Shop Drawing Submittal Review

Project Name: Webster University-**ISB**

Copies	No.	Description
1 PDF	224216P02	(Submittal No.'s)
		(Cannon #22 4216.16-001) - (Paric #15051-) – (WES #607)
		➢ **Commercial Sinks**
		• Clinical Service Sink CSS-1
		• Scrub Sink SS-1
		• Sink SK-1
		• Garbage Disposer GD-1
		• Sink SK-2
		• Sink SK-3
		• Mop Sink MS-1
		• Kitchen Sinks KS-1, KS-2, KS-3

PROJECT NAME:	Webster University ISB
LOCATION:	St. Louis Missouri
CLIENT PROJ. NO.:	N/A
WES PROJ. NO.:	607
SPEC SECTION:	22 4216.16 Commercial Sinks
SUBMITTAL ITEM:	See Below -

SCR1B/ SCR09/ SCR19/ SCR39/ SCR49 Multi-Turn Angle Stop w/ Loose Key – Compression x Compression

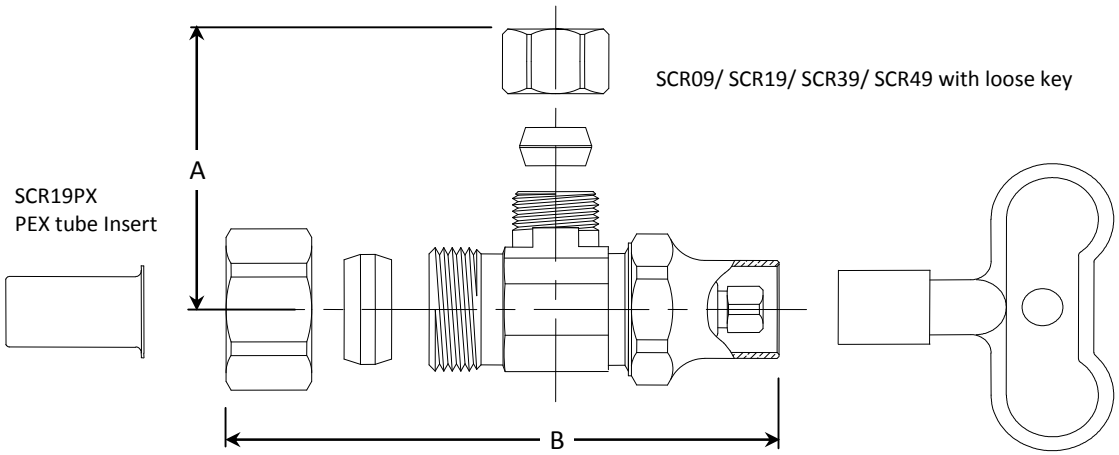
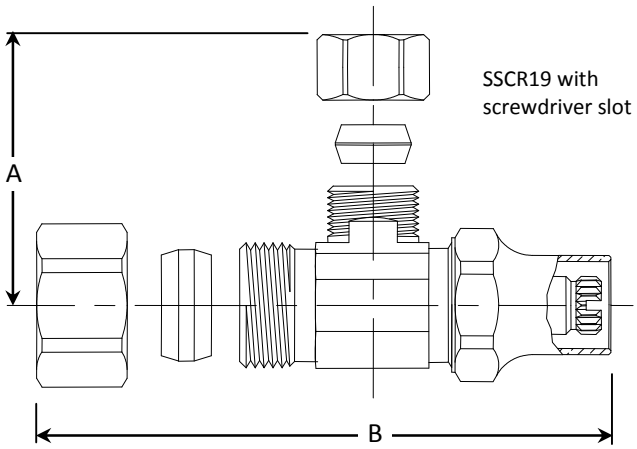
1. Provide under counter waste and supply protective piping covers as required. Verify requirements with the architectural drawings.
.
2. Escutcheons are specified to be cast brass. Refer to specification section 220518.
